ADDENDUM NO. 3

DATE: July 7, 2021

**RELOCATABLE CLASSROOM AT VARIOUS SITES
& SITE IMPROVEMENTS**

**CLOVIS UNIFIED SCHOOL DISTRICT
CLOVIS, CALIFORNIA**

A-3

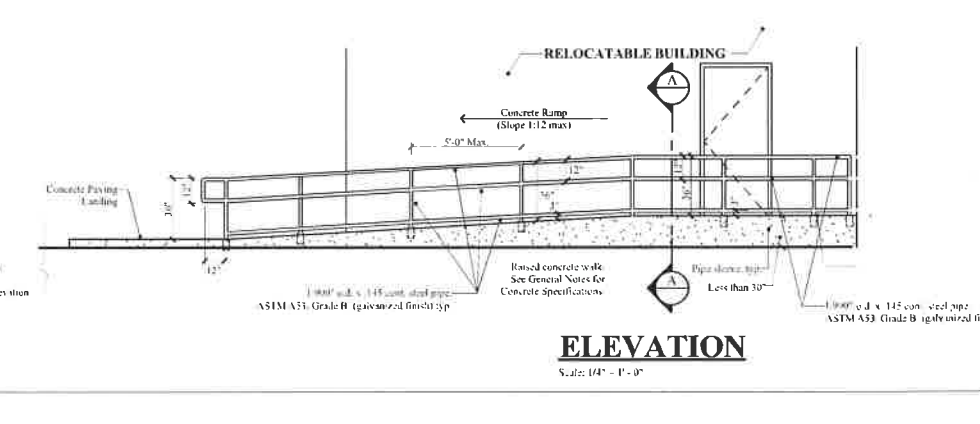
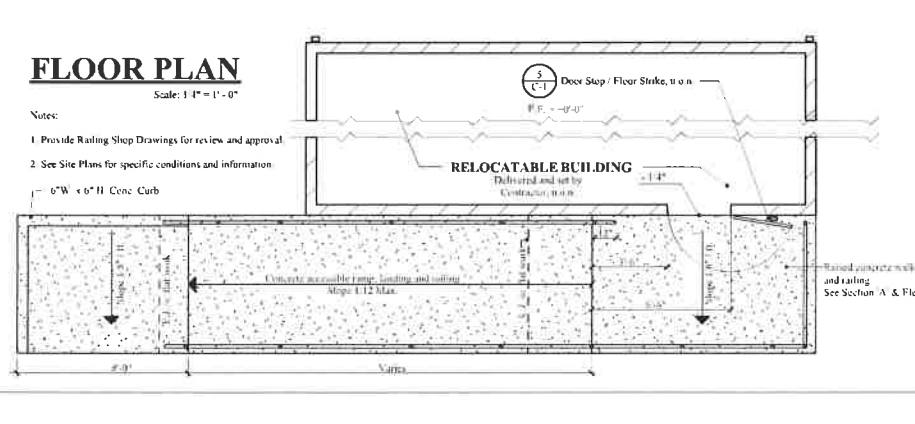
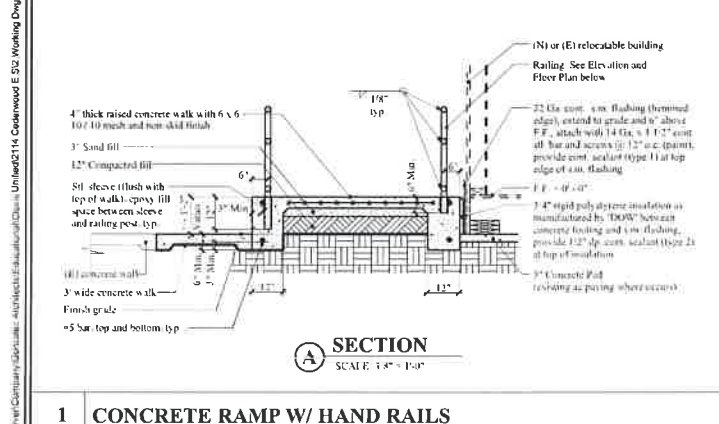
Refer to Sheet A-3

An additional portable building is being added to the Cedarwood Campus.
Remove and replace the following sheets with attached sheets.
C, C-1, A-1, A-3, E-3, E-4, E-5, & E-6.

E-3

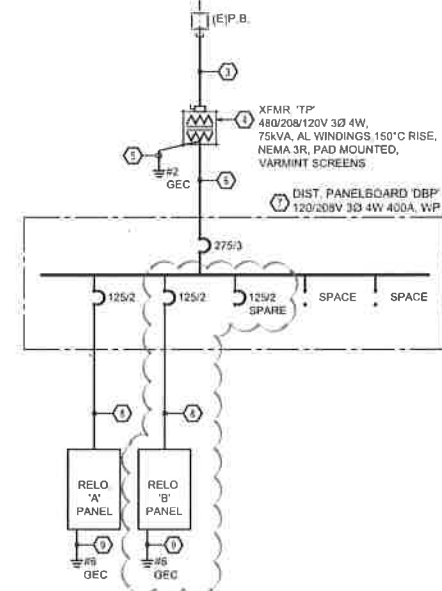
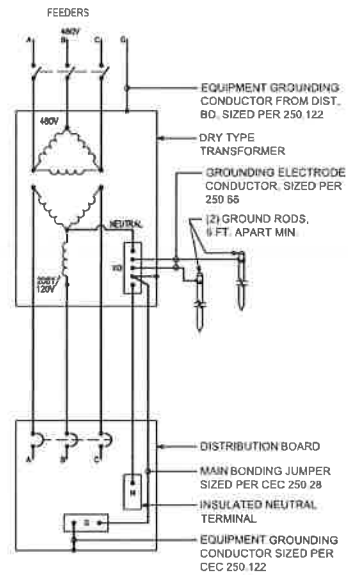
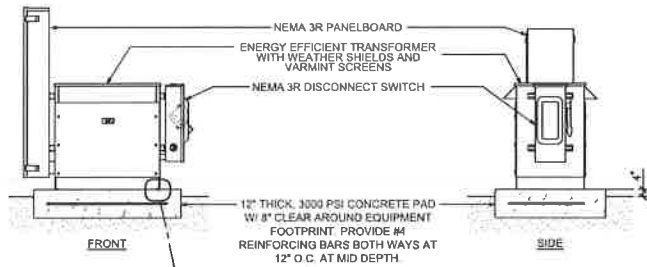
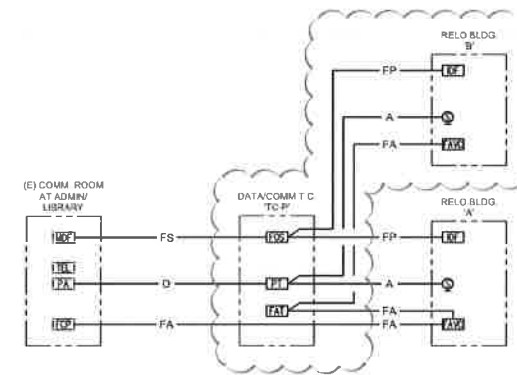
Refer to sheet E-3

1. Revised Power Single Line Diagram for additional relocatable classroom.
2. Revised Site Comm/Signal Line Diagram for additional relocatable classroom.

E-4

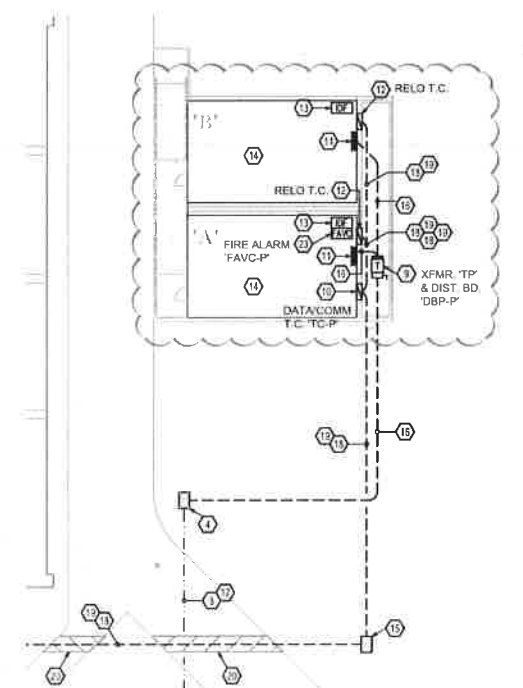
Refer to sheet E-4

1. Revised Electrical Site Plan for additional relocatable classroom.
2. Revised Enlarged Elec. Site Plan for additional relocatable classroom.
